Project: Heber Valley Hospital Fluoroscopy Replacement
Addendum 1

Date: August 8, 2024

From: HKS Architects, Inc
90 South 400 West, Suite 110
Salt Lake City, Utah 84101
(801) 532-2393

1 LEVEL 1 POWER PLAN
 SCALE: 1/4" = 1'-0"

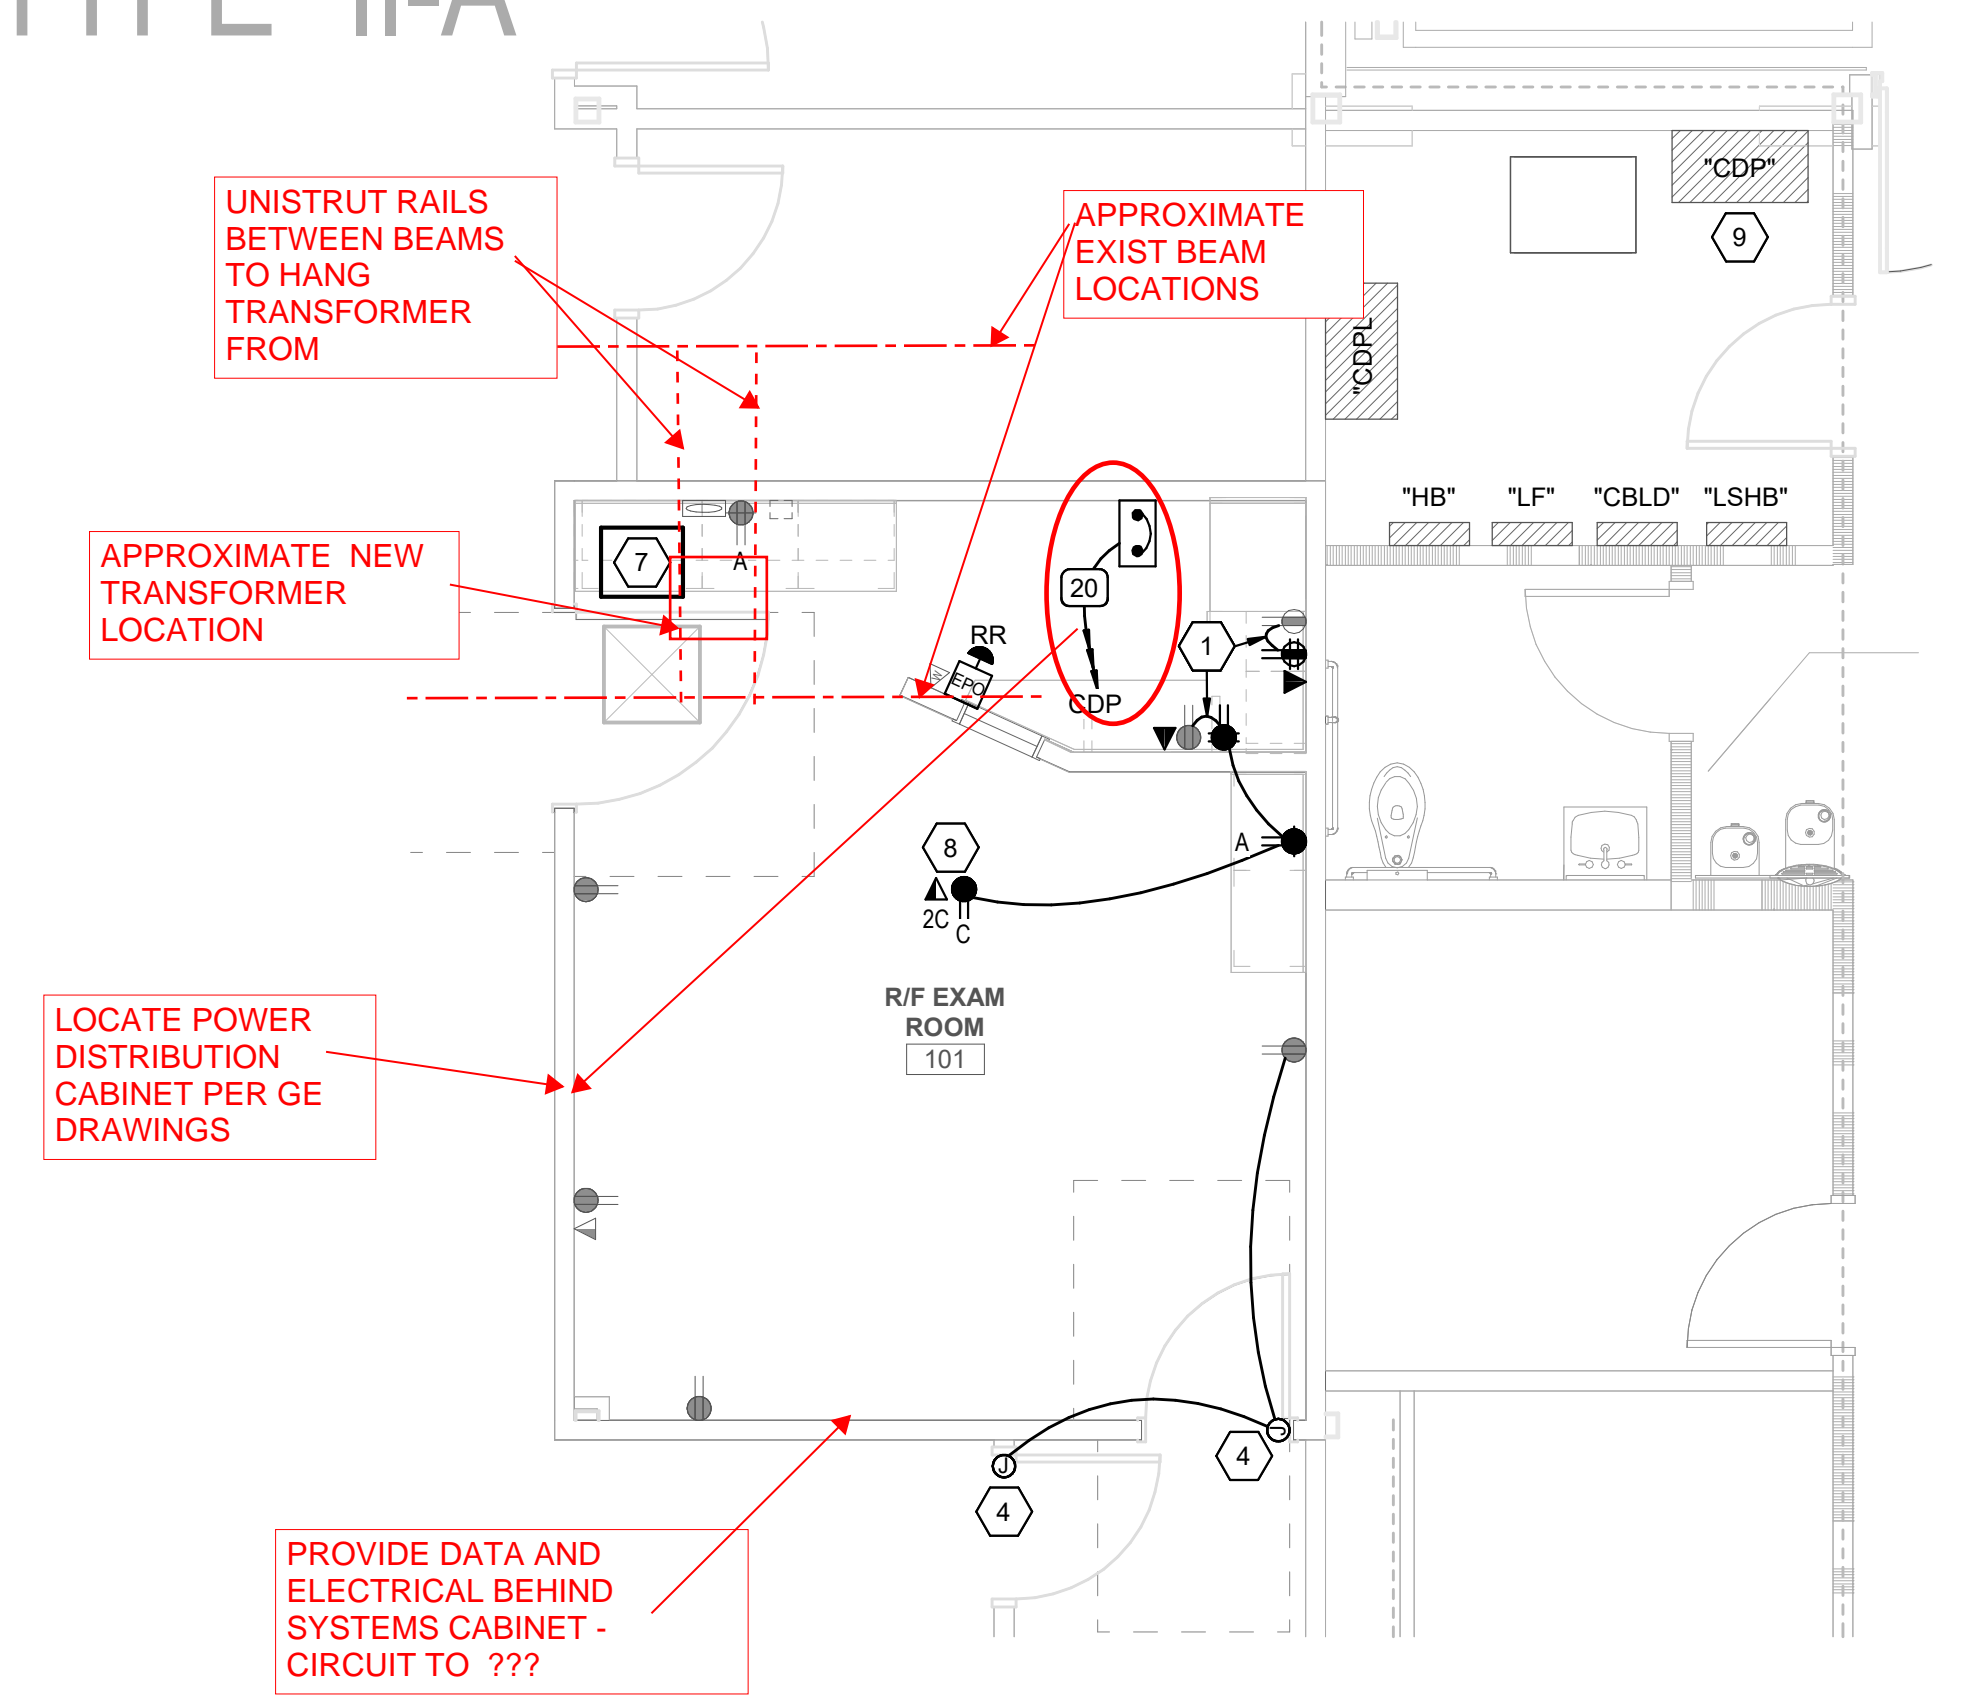
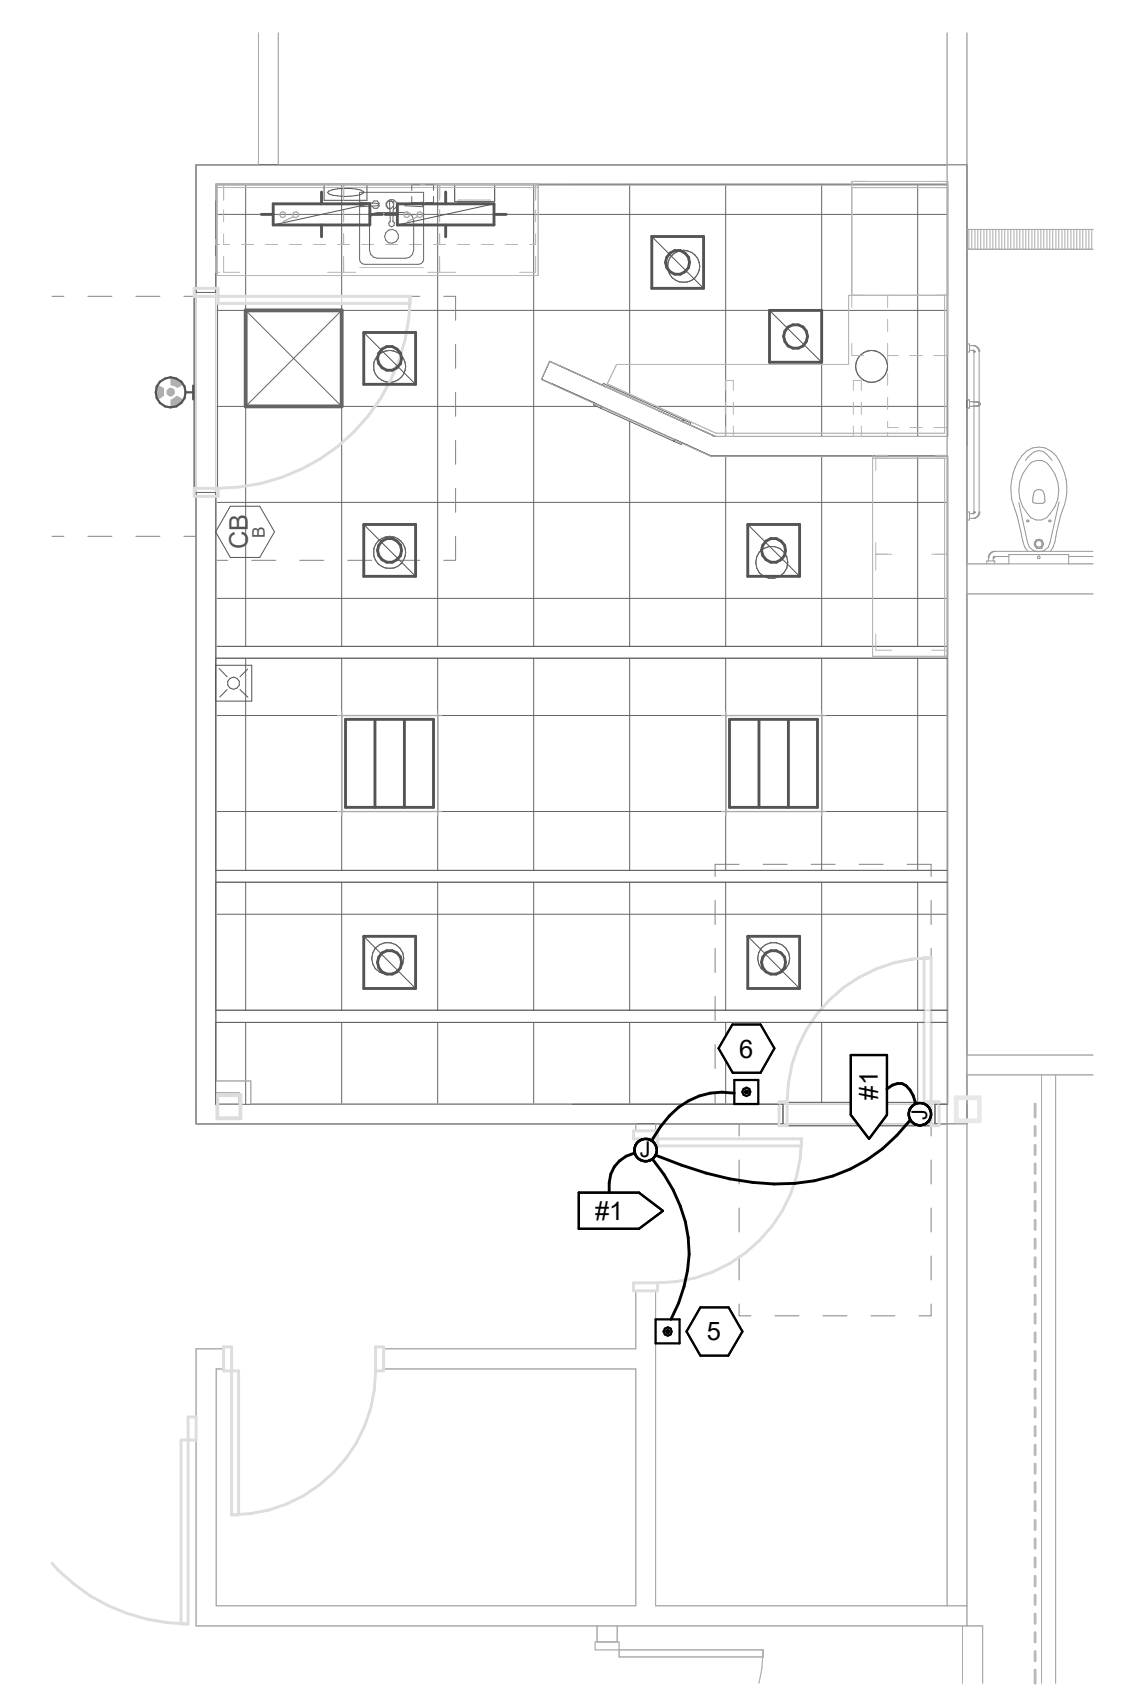
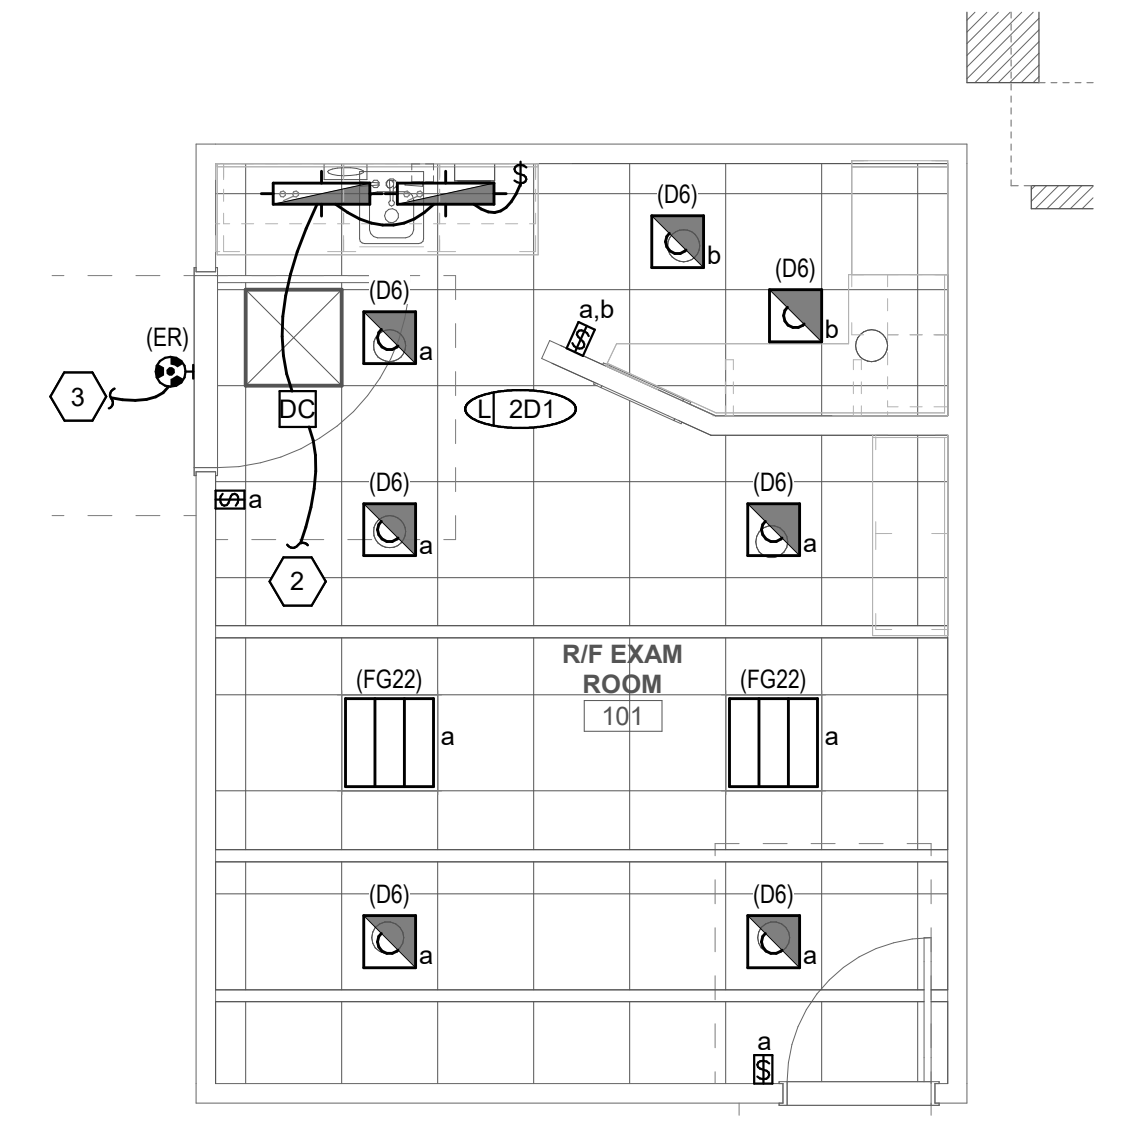
1. On sheet EP101 the GE panel on the wall is shown in the control area. GE drawing shows it out in the room
 - a. GE panel, item 1, shall be in the main room, as indicated on GE drawing 13/16, and will be provided by GE

4. GE drawings show a power and data behind the digital systems cabinet. EP101 sheet doesn't.
 - a. Provide data and electrical behind item 14 on GE drawing 13/16 as indicated. Provide dedicated circuit to outlet.

8. Suggested support for the new transformer is indicated on EP101, with suitable slotted channel framing materials between beams (fastened to beam bottom flange), with vertical rods and slotted channel framing under the transformer, braced for seismic movement as required.
 - a. Existing beams have a spray applied fireproofing material on them. Spray applied fireproofing material shall be patched where disturbed by new support anchorages, etc.

LOCATION INDICATED FOR THE TRANSFORMER SHALL BE MODIFIED AS SHOWN (LOCATION SHOWN IS A MORE VACANT SPACE ABOVE THE CEILING). CONTRACTOR SHALL PROVIDE UNISTRUT RAILS (APPROPRIATE SIZED) BETWEEN EXISTING BEAMS TO SUPPORT THE TRANSFORMER
